DESIGN AND CONSTRUCTION MANUAL DESIGN MODIFICATION REQUEST

PROJECT NAME: Longview Mansion – Parking Lot Addition

RE: PL2023291 – Longview Mansion – Parking Lot Addition

EXHIBIT
EX-04

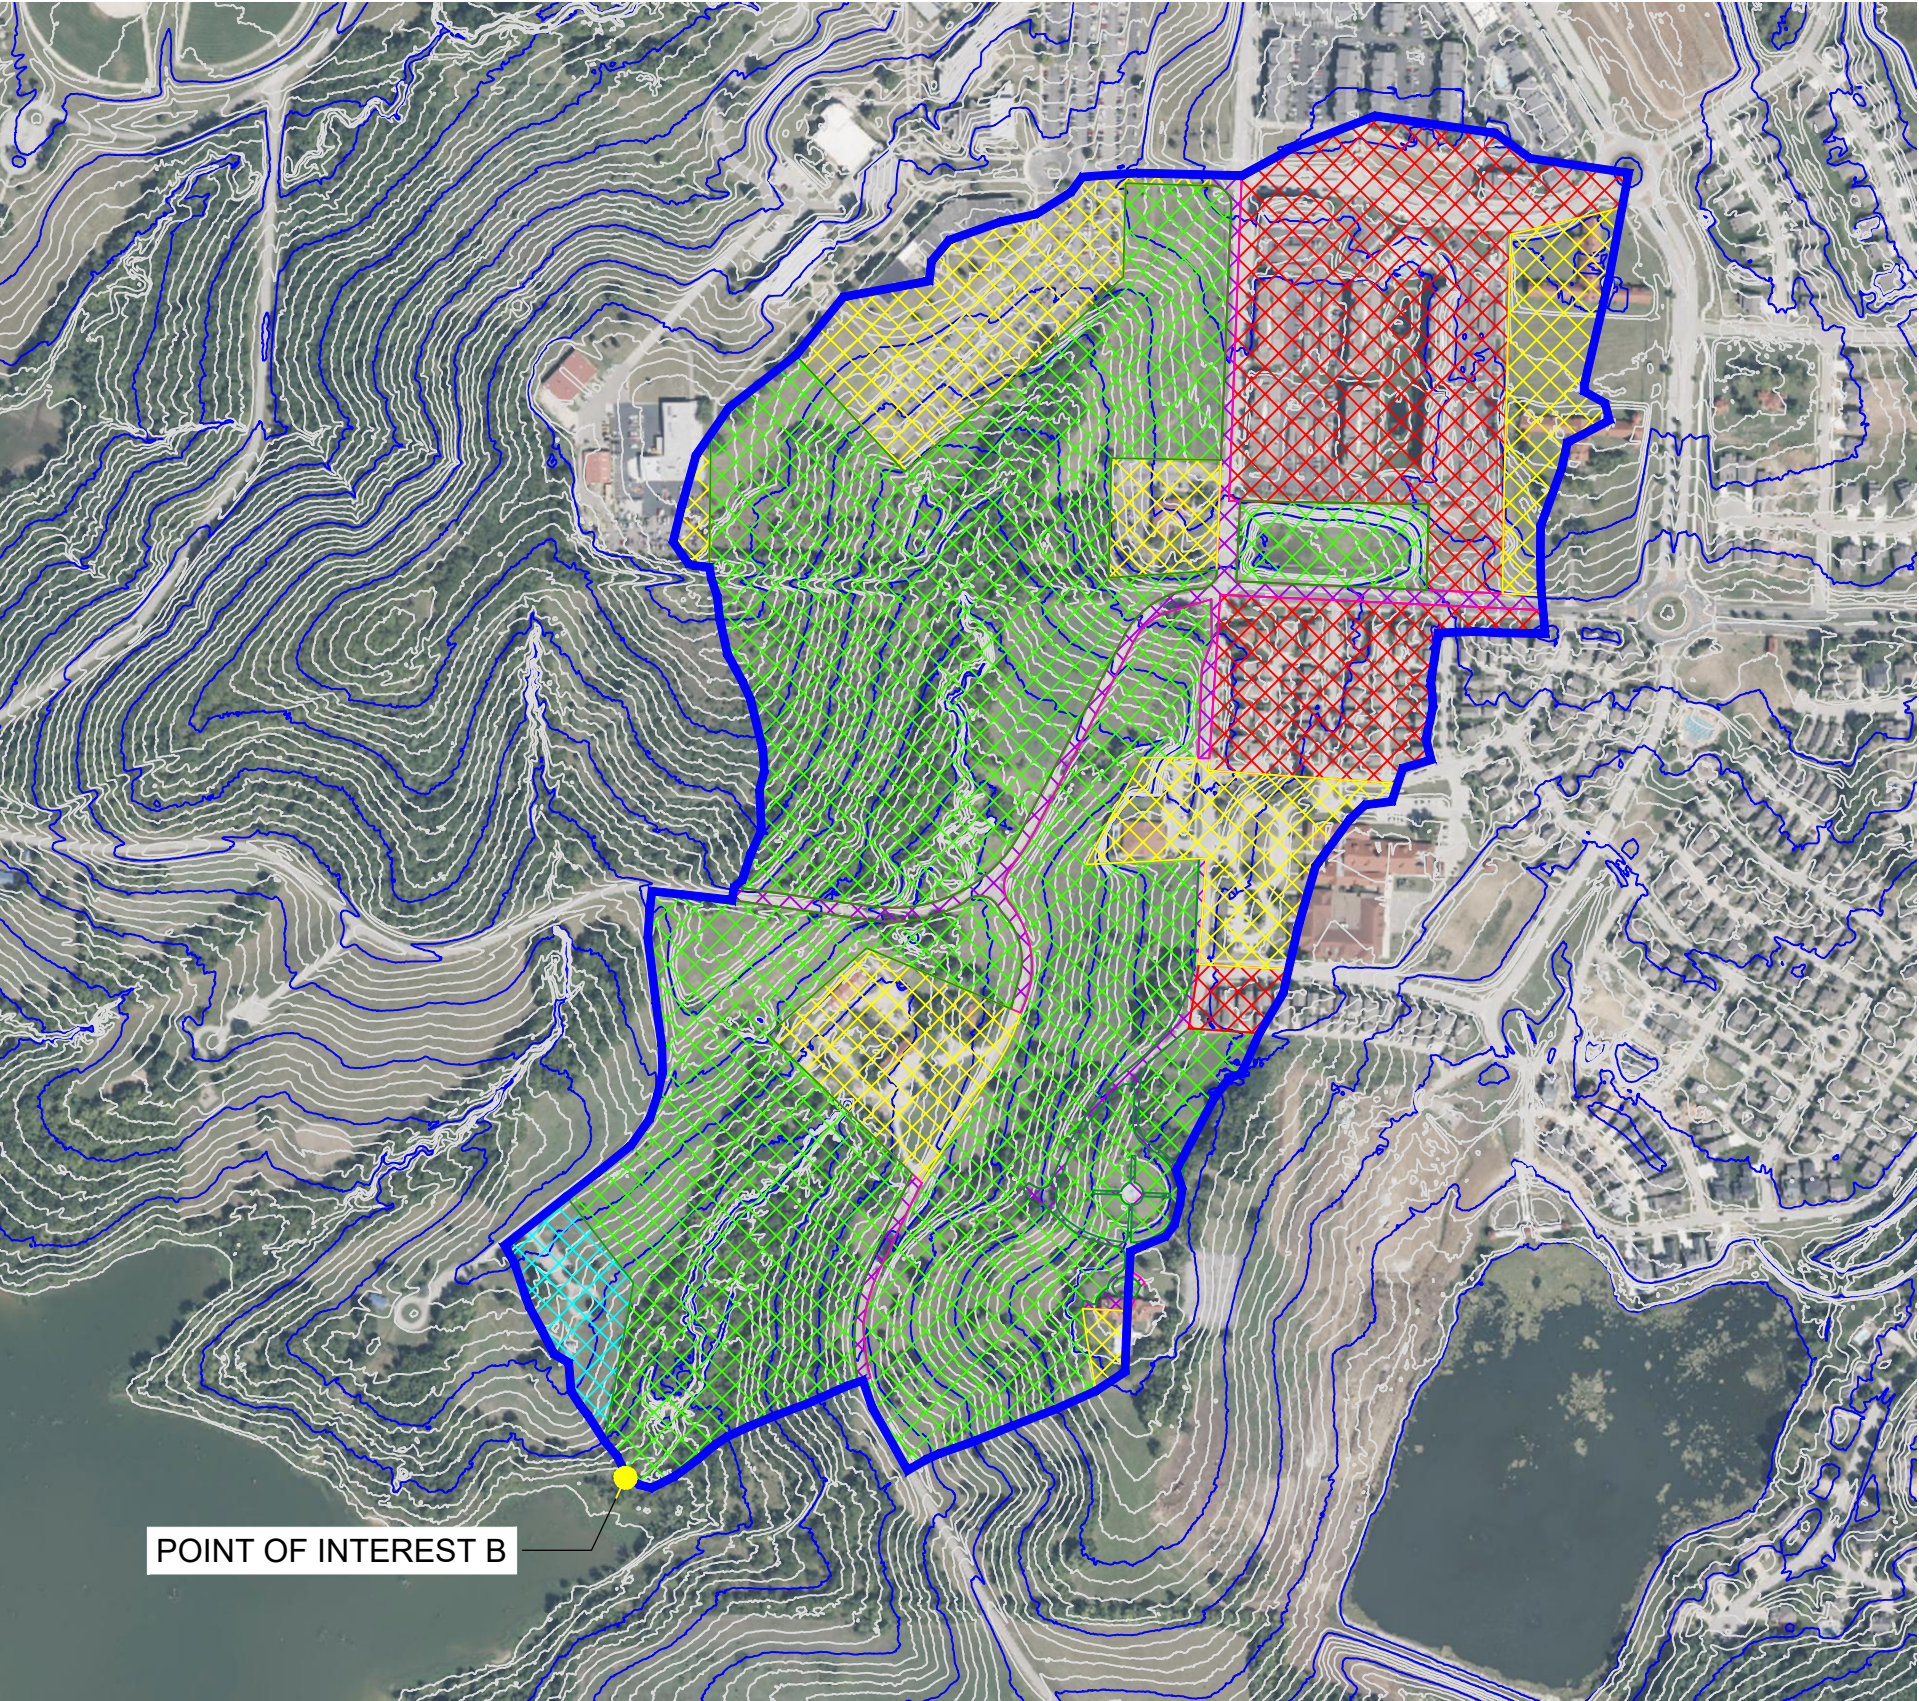
There is an existing unnamed tributary between the county road and the lake that collects stormwater for a watershed of 133.66 acres, for which the proposed site accounts for ~0.75% of the watershed. This tributary was analyzed in existing conditions with a 5' bottom width and 8' depth with 3:1 slopes, and was determined to have flowrates at the point of entry to the lake (Point of Interest B, see Exhibit EX-04) as shown in the table below:

As shown in the table above, the percent increase of stormwater flow in the tributary area is less than 0.3% for the watershed in all stormwater events, and even decreased in the 10-year event.
